AMENDMENT

ETS 300 324-1

**This amendment A1 modifies
the European Telecommunication Standard ETS 300 324-1 (1994)**

**Signalling Protocols and Switching (SPS);
V interfaces at the digital Local Exchange (LE);
V5.1 interface for the support of Access Network (AN);
Part 1: V5.1 interface specification**

Page 218, figure L.17.2

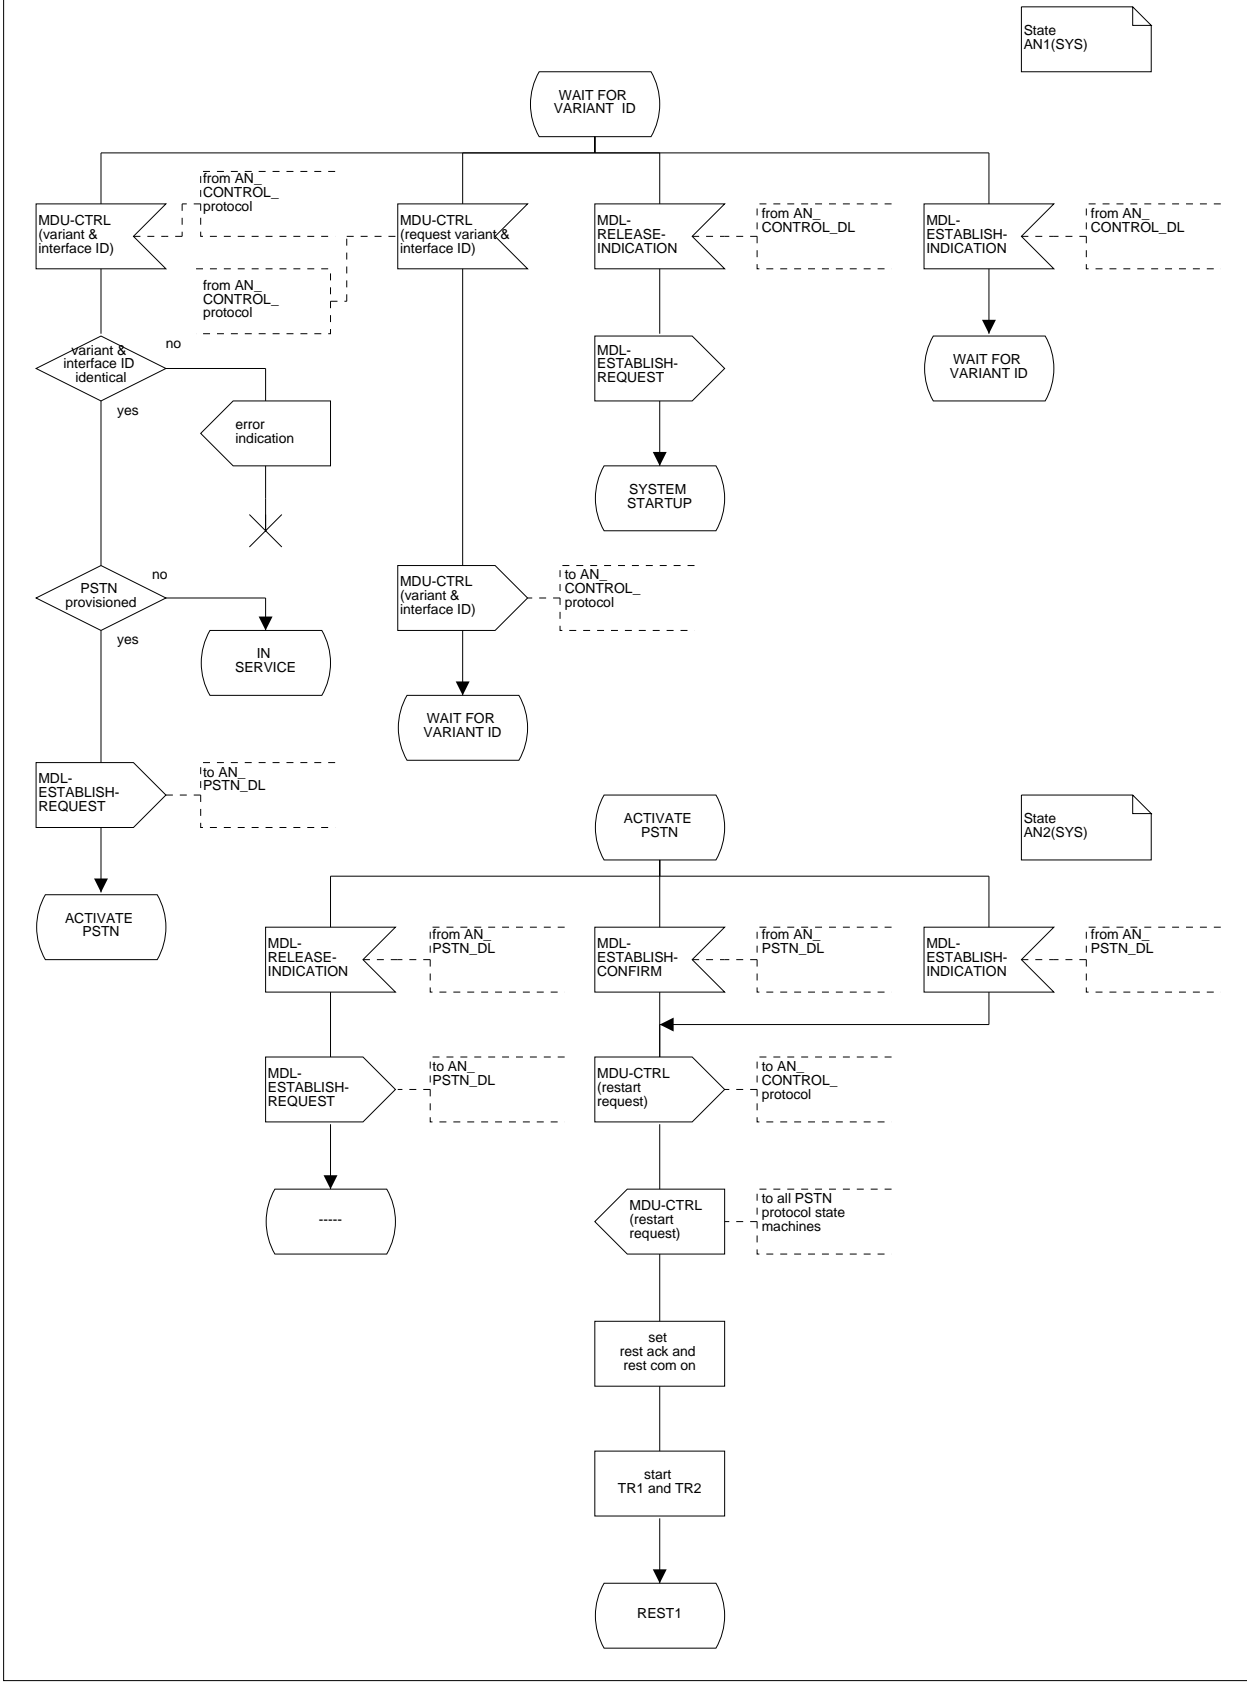
- Annex L, figure L.17.2: Figure L.17.2 is contradictory to annex C, item 13), which requires that the variant and interface ID shall be checked during system startup. Figure L.17.2 shows only a check of the interface ID.
Amendment: Update of figure L.17.2 by adding a decision for the correct variant.

State "WAIT FOR VARIANT ID", branch "MDU-CTRL (variant&interface ID)":
Replace decision "ID identical" by "variant&interface ID identical".

State "WAIT FOR VARIANT ID":
Add a new branch "MDU-CTRL(request variant&interface ID)" as shown below.

State "ACTIVATE PSTN":
Add a new branch "MDL-RELEASE-INDICATION" as shown below.

Page 220, figure L.17.4, state "IN SERVICE", branch "MDU-CTRL (restart request)"

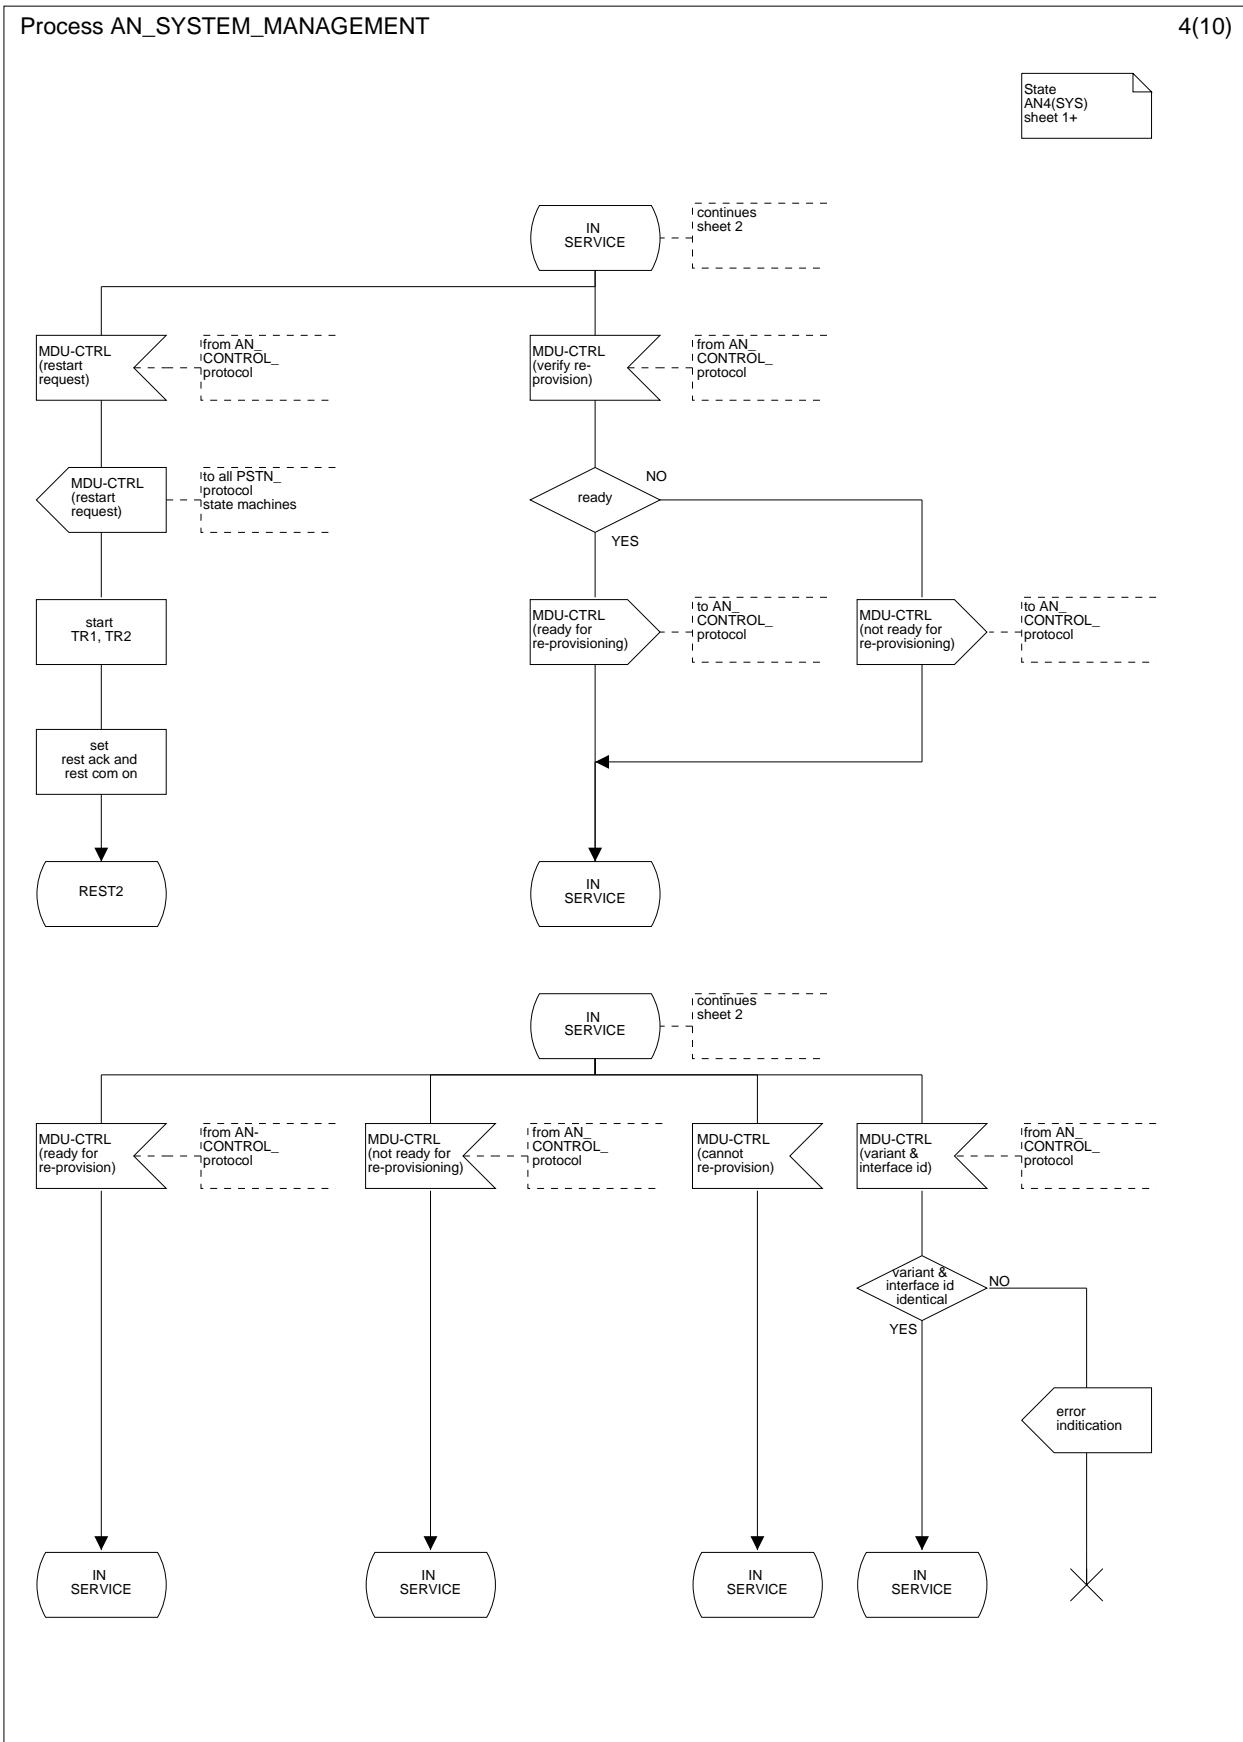
Replace task "set rest ack on" by task "set rest ack and rest com on". Replace task "start TR1" by task "start TR1, TR2".

Page 223, figure L.17.7, state "ANY STATE Except AN0, AN1"

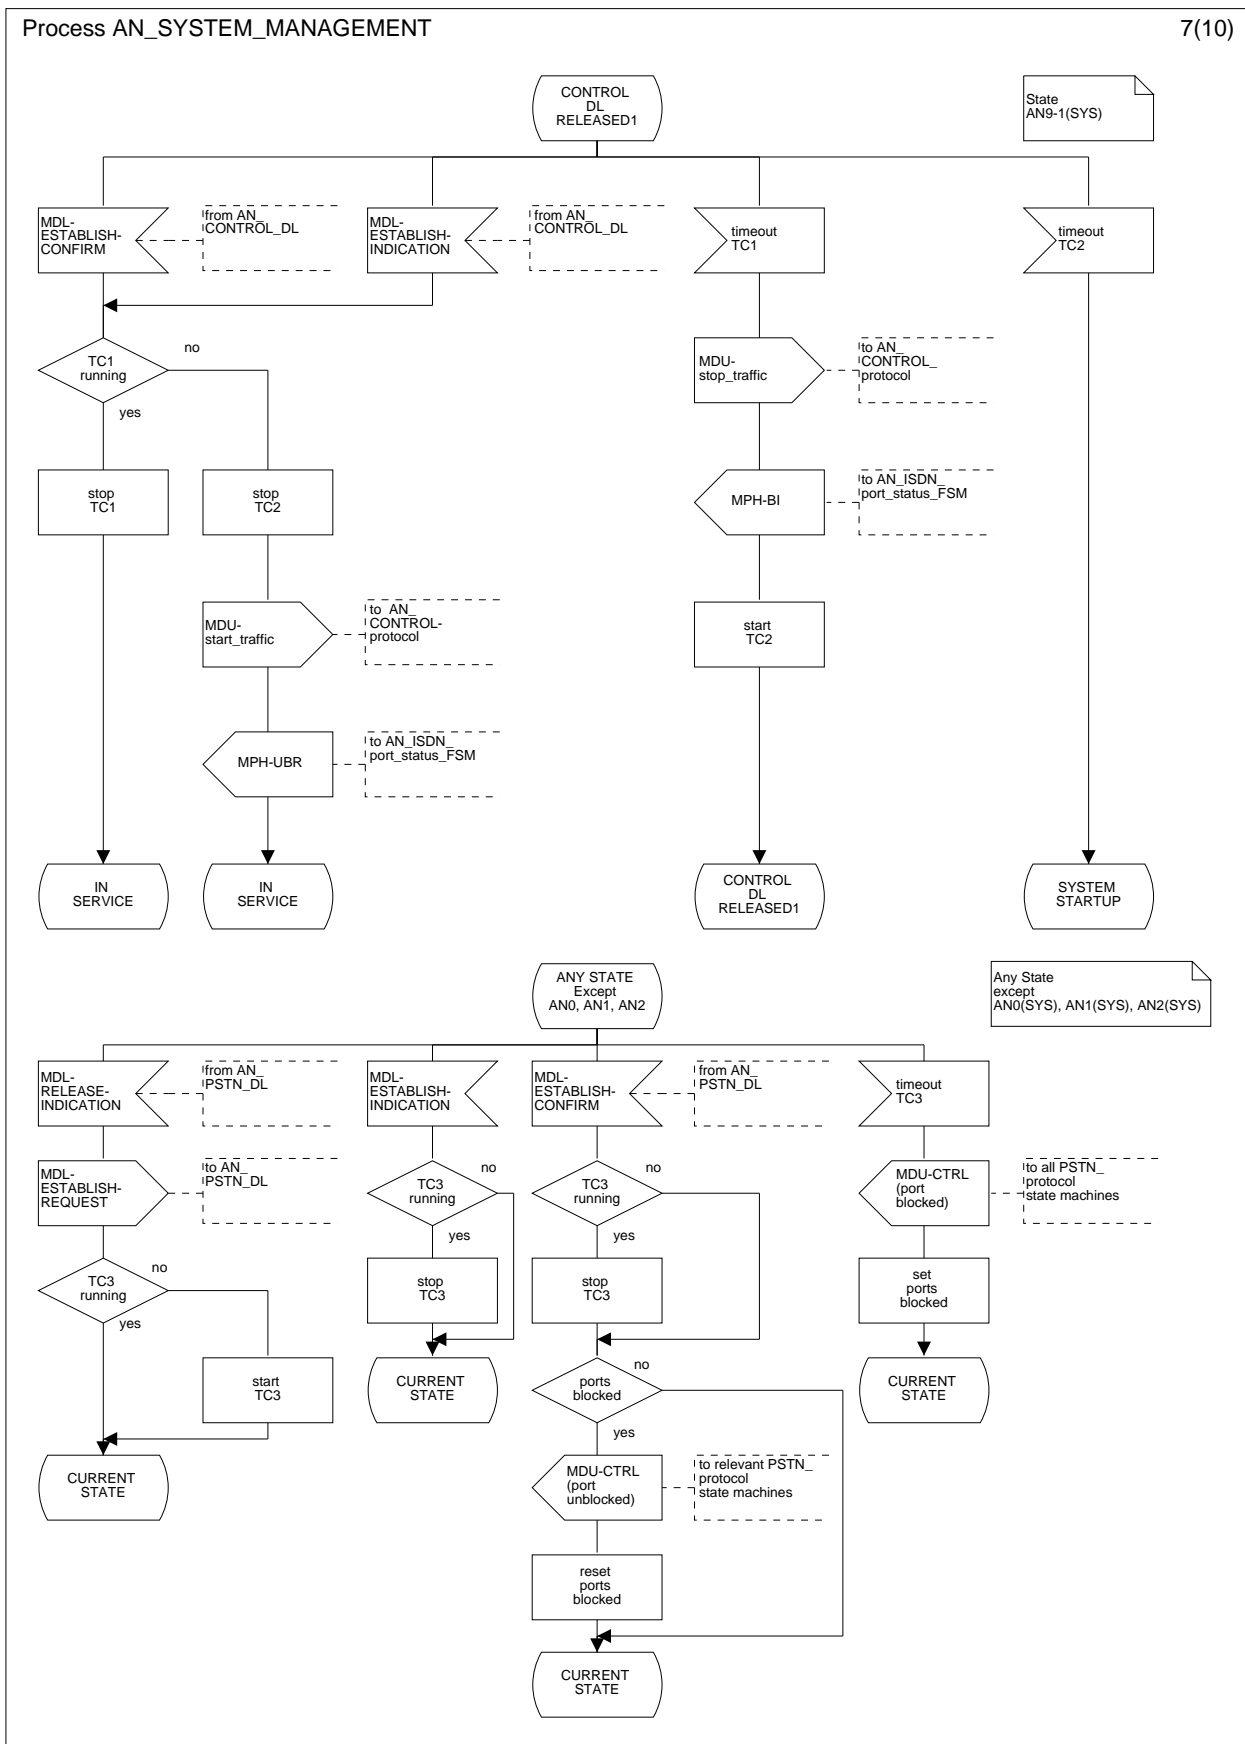
- The handling of DL release is missing in states AN2/LE2(SYS) (Activate PSTN).
Amendment: Take into account MDL-RELEASE-INDICATION from AN/LE PSTN_DL.
- Annex L, figure L.17.7: The recovery from PSTN_DL release is not working properly.
When MDL-RELEASE-INDICATION is received, timer TC3 is started and MDL-ESTABLISH-REQUEST is sent to PSTN_DL. When PSTN_DL receives MDL-ESTABLISH-REQUEST it sends a SABME command over the V5.1 interface. IF PSTN_DL receives no response, it repeats the SABME three times having breaks of 1 second between each transmission. If PSTN_DL does not receive any response from the remote side after up to 4 seconds it will send again MDL-RELEASE-INDICATION to system management, which then starts TC3 again and returns MDL-ESTABLISH-REQUEST to PSTN_DL.
Amendment: TC3 is fixed to 15 seconds, and thus it will never time out.

When PSTN_DL finally manages to re-establish the connection and returns MDL-ESTABLISH-CONFIRMATION to system management, the condition "TC3 running" is insufficient to determine the status of the PSTN ports (blocked or unblocked). Assume that TC3 could time out. The PSTN ports will then be blocked. If MDL-RELEASE-INDICATION is however once more received, TC3 is restarted. Then if MDL-ESTABLISH-CONFIRMATION is received TC3 is running but the port unblock procedure would need to be initiated.
 Amendment: Update of figure L.17.7 to avoid deadlocks.

Change "ANY STATE except AN0, AN1" to "ANY STATE except AN0, AN1, AN2".

TC3 is only started if not running.

MDU-CTRL (port unblocked) is only sent if ports are blocked. Insert a new decision.

A new flag "ports blocked" is set in order to support the new decision in branch "MDL-ESTABLISH-CONFIRM".

Page 224, figure L.17.8, state "REST2"

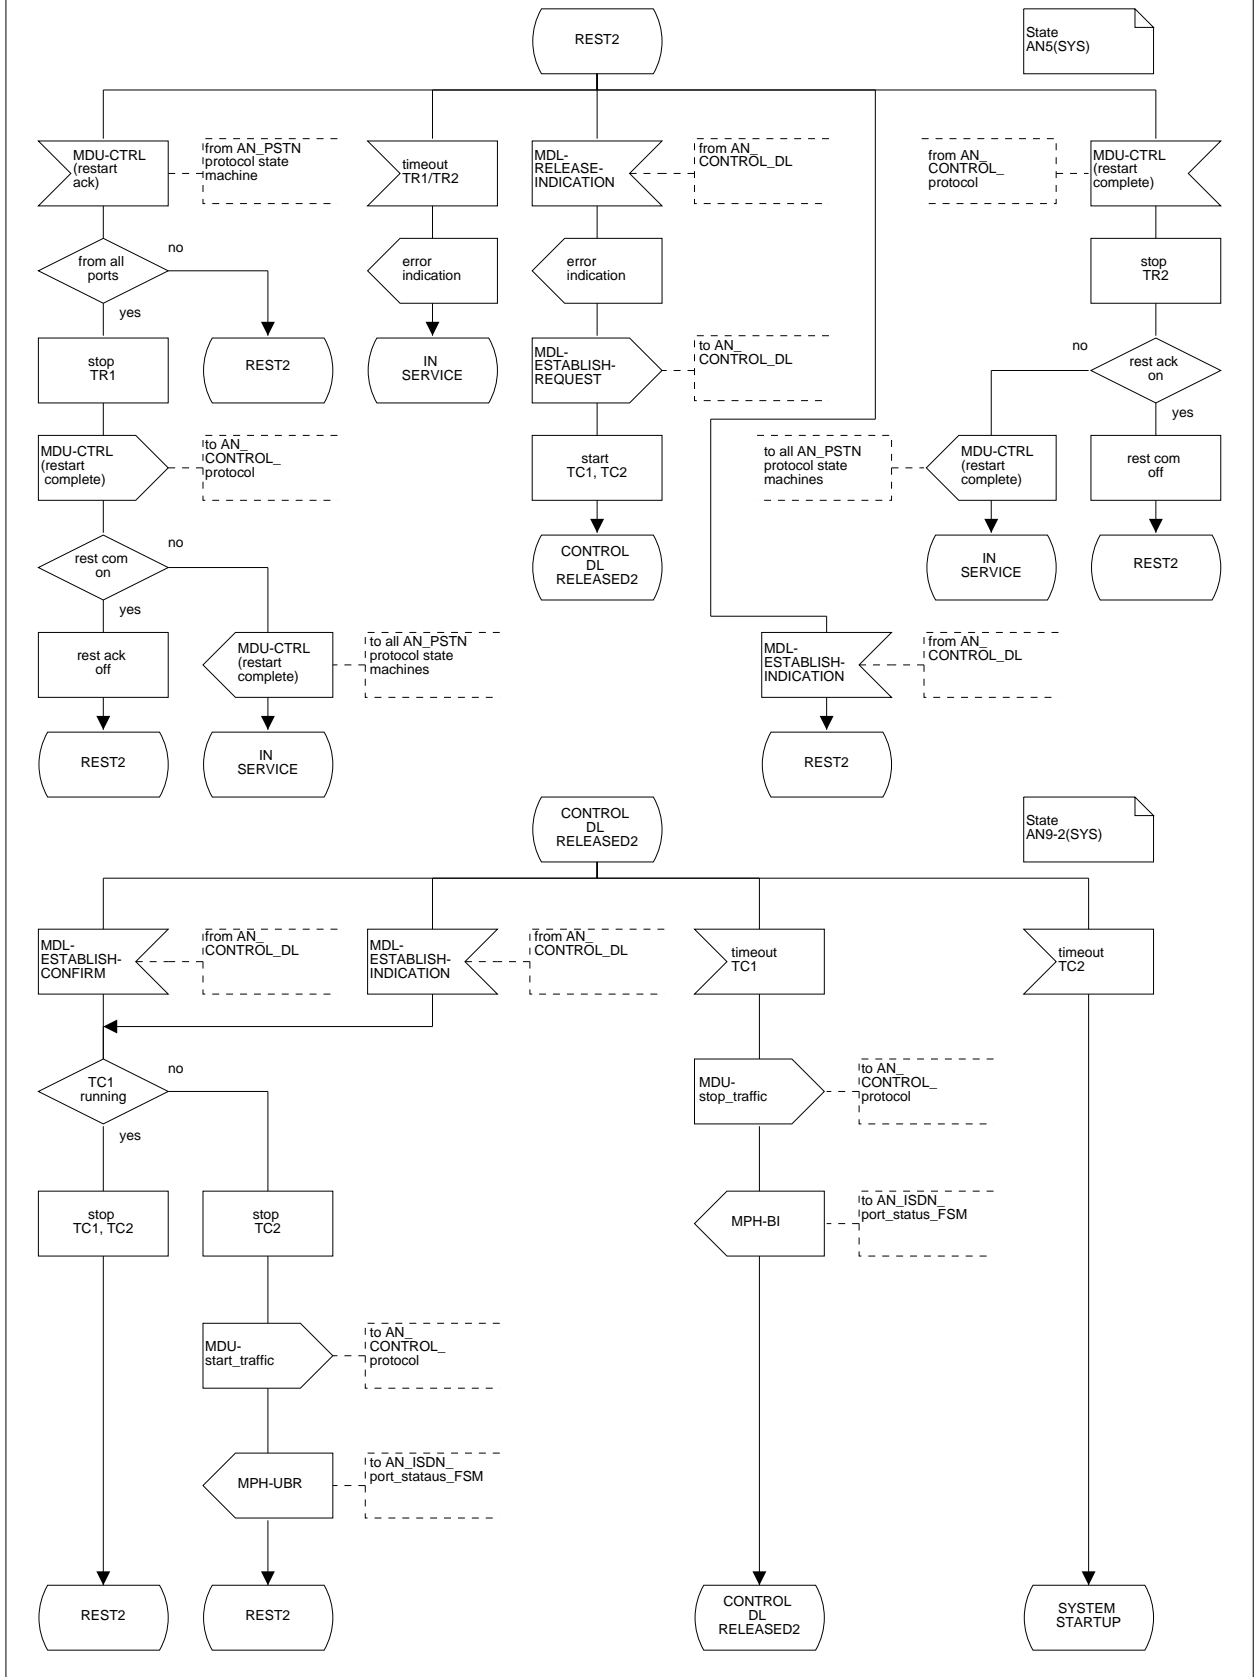
Use the same tasks as in state "REST1", branch "MDU-CTRL (restart ack)" of figure L.17.3.

Replace event "timeout TR1" by "timeout TR1/TR2".

Use the same tasks as in state "REST1", branch "MDU-CTRL (restart complete)" of figure L.17.3.

Page 235, figure L.25.1, state "OUT OF SERVICE"

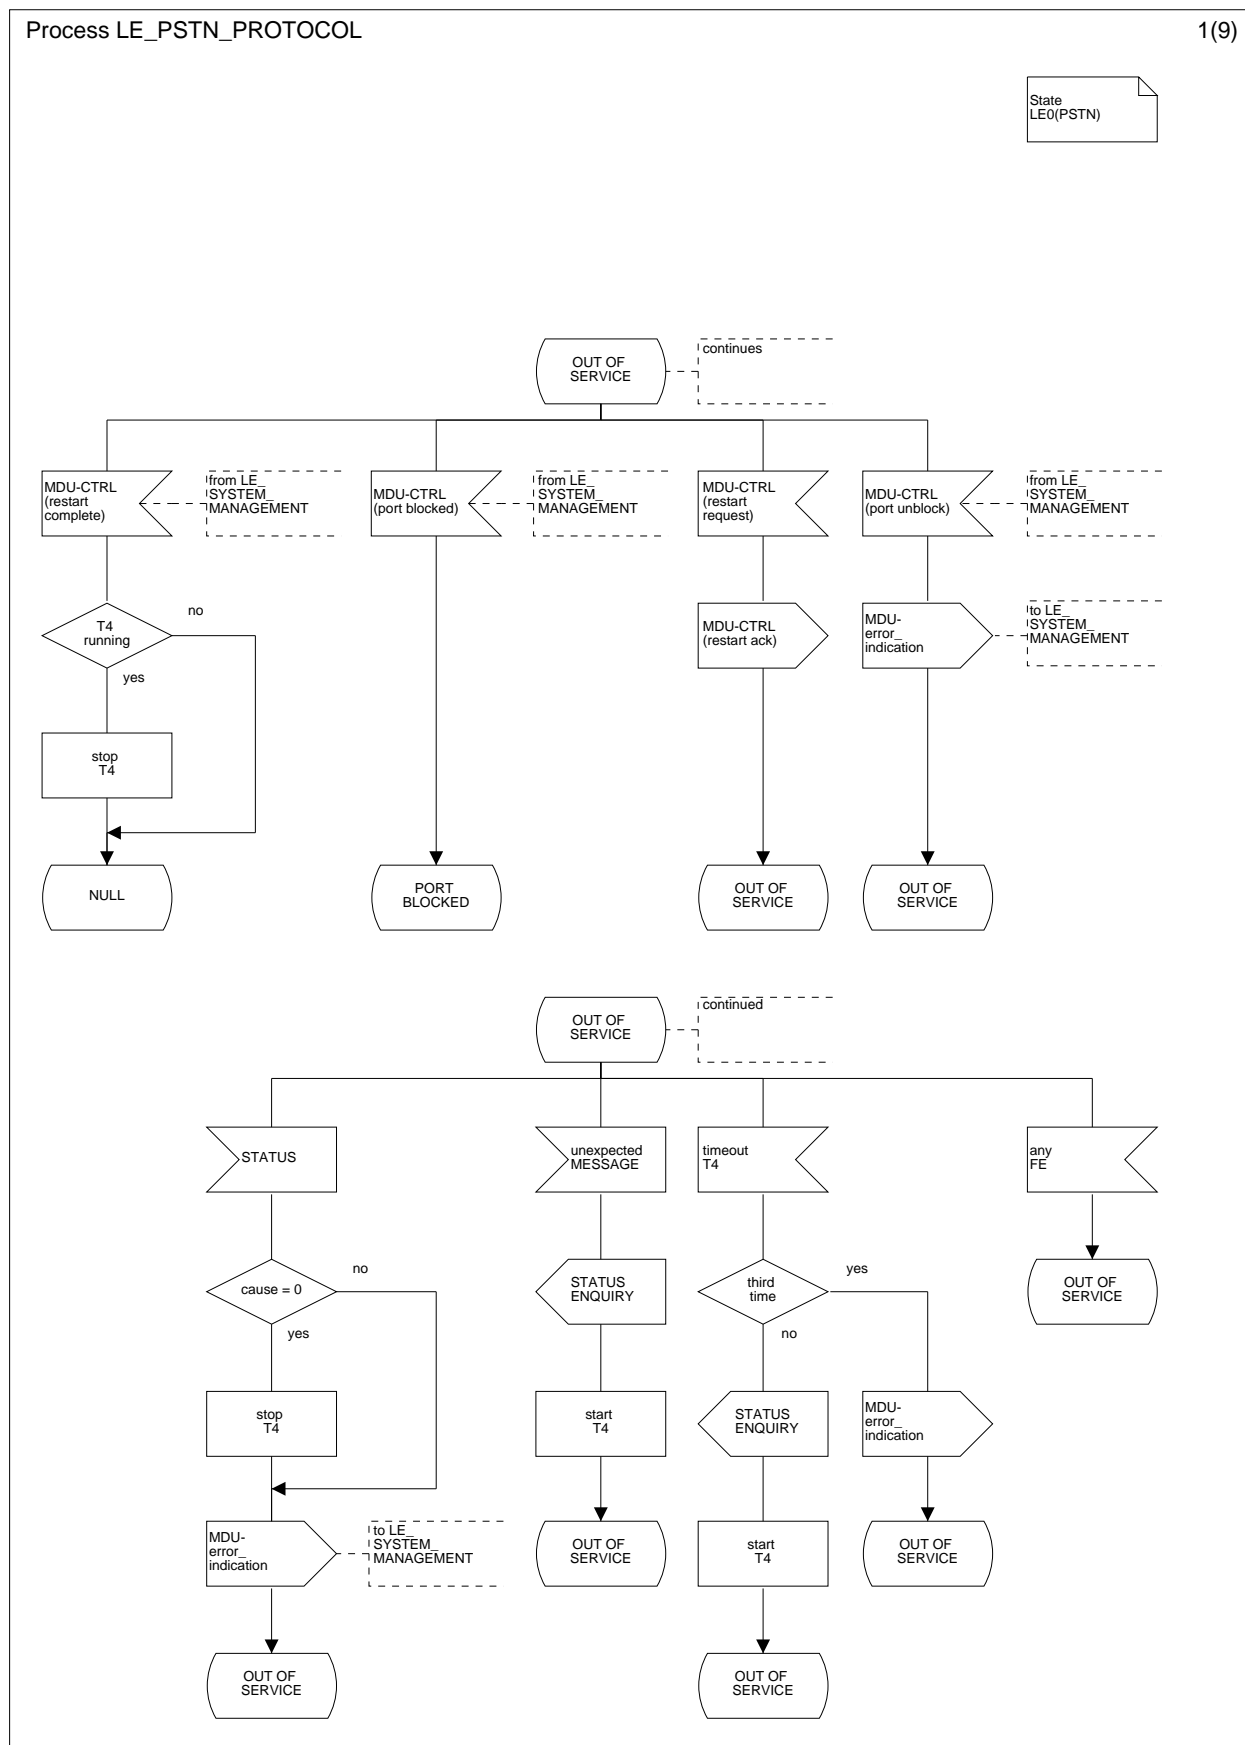
Delete the start symbol.
